CITY OF WARWICK

MEMORANDUM

Re: Major Land Development: 175 Post Road Master Plan Application

Location: 175 Post Road
Assessor's Plat: 291
Assessor's Lots: 45 & 74
Applicant: Artak Avagyan and Lee Beausoleil
Zoning: Light Industrial (LI)
Land Area: 15.67 acres
Ward: 6
Engineer: DiPrete Engineering

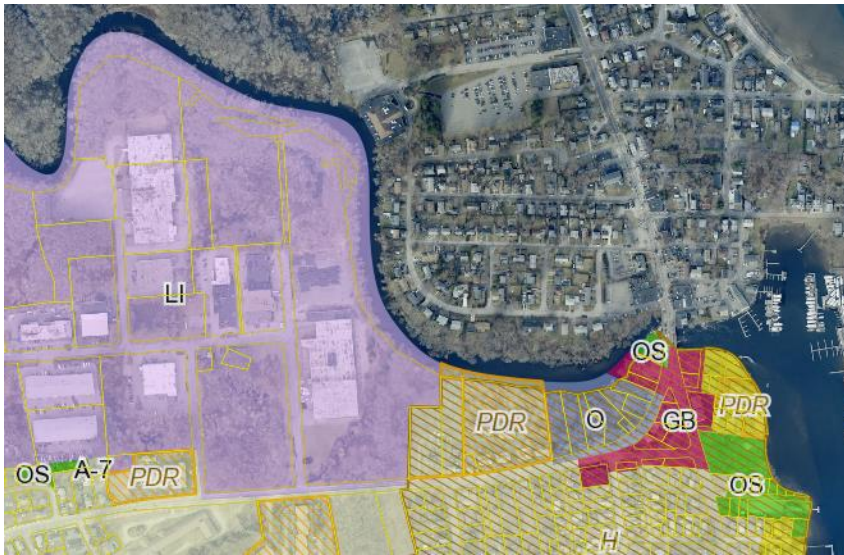
5. **Development within the floodway and wetlands** – Part of the proposed development is located within the Pawtuxet River floodway that occupies the north side of the property. The buildings have been removed from the floodway areas in a revised design, however stormwater measures and impervious parking areas remain within the floodway.
